City of  
Richmond

## Report to Development Permit Panel

**File:** DP 11-564405

**Re:** **Application by Dava Development Ltd. for a General Compliance Ruling at Portions of 10111, 10197 & 10199 River Drive (formerly Portions of 10111 & 10199 River Drive)**

Reference Plan Sept 15, 2016  
**DP 11-564405**

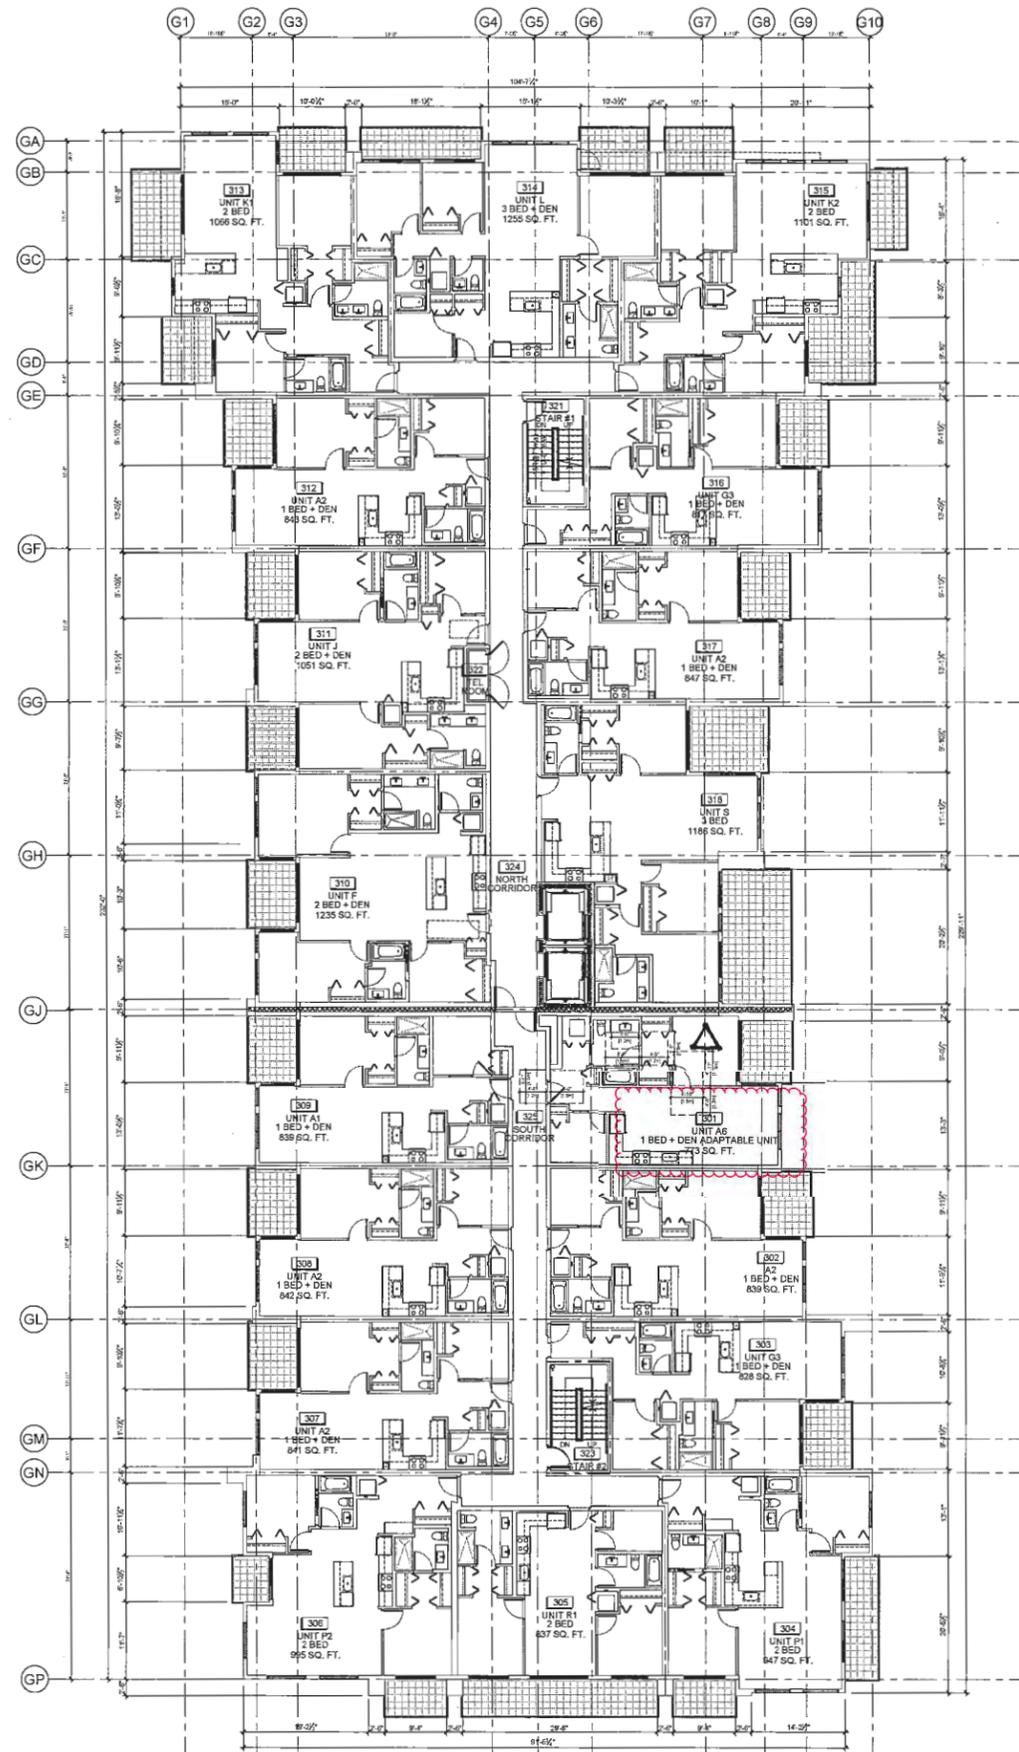
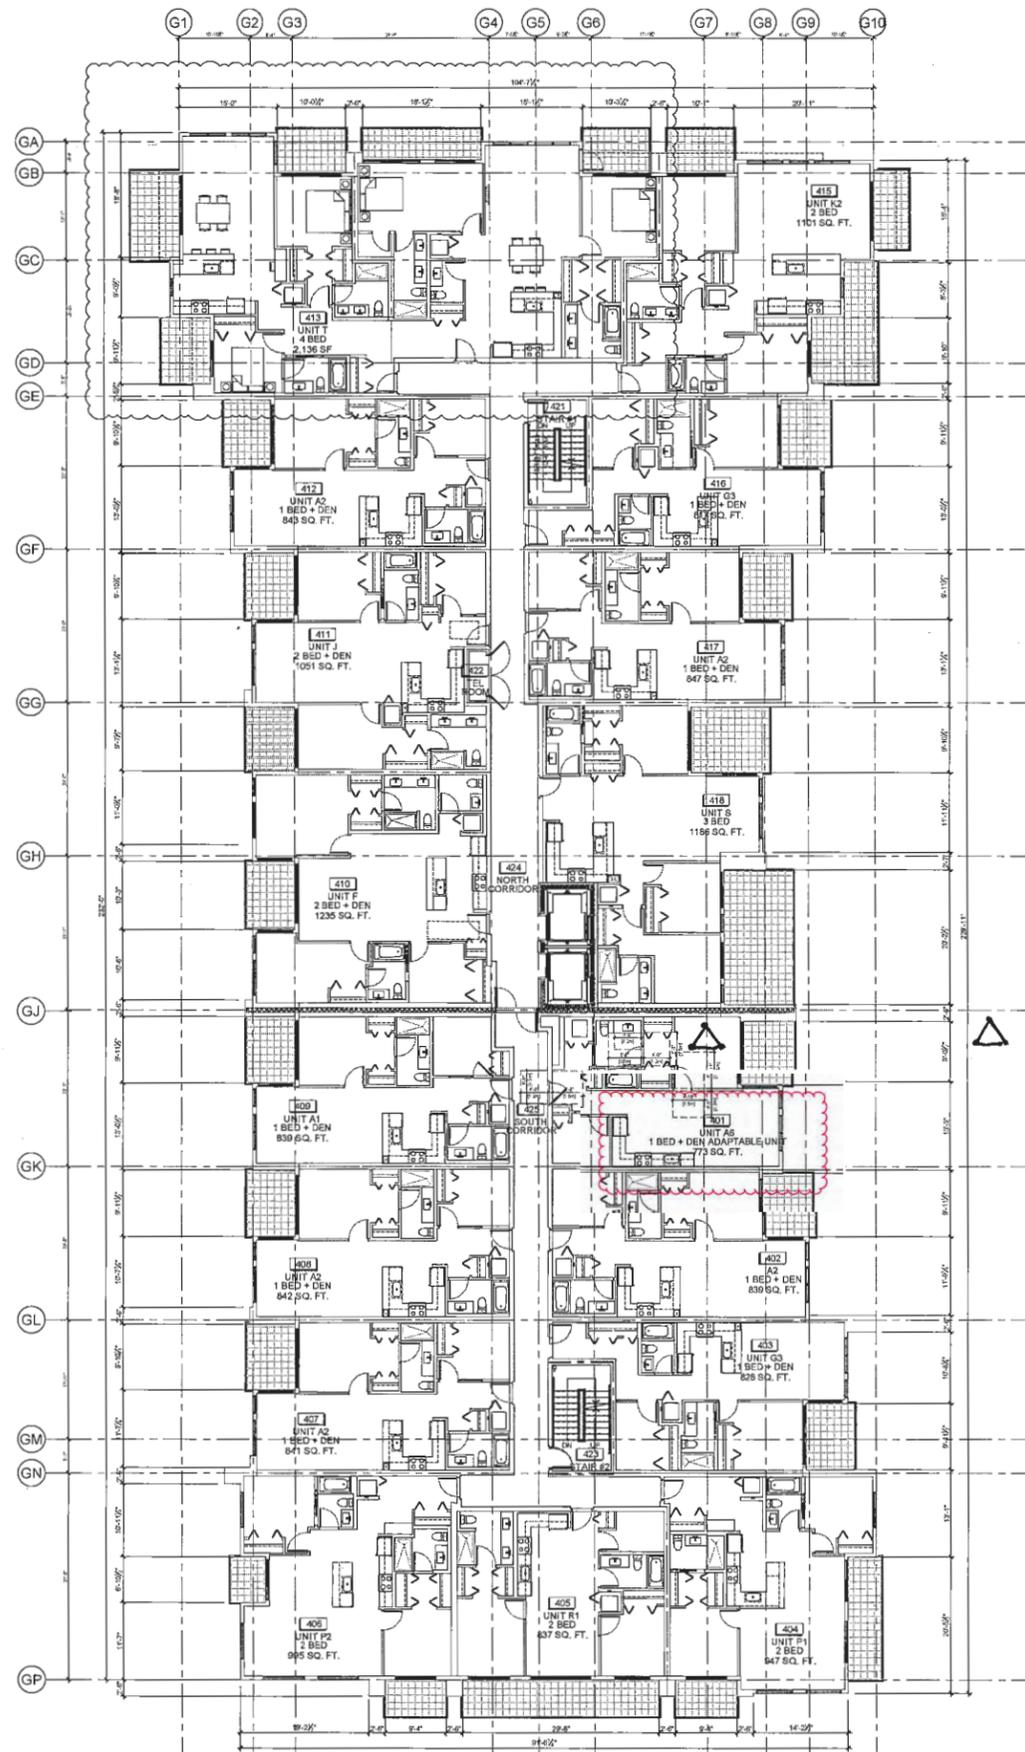
Replacement reference plan  
with Adaptable Units in  
Building G

△ ADAPTABLE  
UNITS (3)  
TO COMPLY  
WITH BCBC

- In addition to the two (2) basic universal housing units noted above, the proposed development also includes three (3) adaptable units that are designed with the potential to be easily renovated to accommodate a future resident in a wheelchair. These three (3) units are proposed to be located on floors 3, 4 & 5 as identified on the replacement floor plans. These single-storey units are required to comply with the BC Building Code requirements for adaptable housing. These units do not include all of the features identified in the Basic Universal Housing Features section of the City’s Zoning Bylaw and therefore, do not qualify for the Zoning Bylaw density exclusion of 1.86 m<sup>2</sup> (20 ft<sup>2</sup>) per unit.
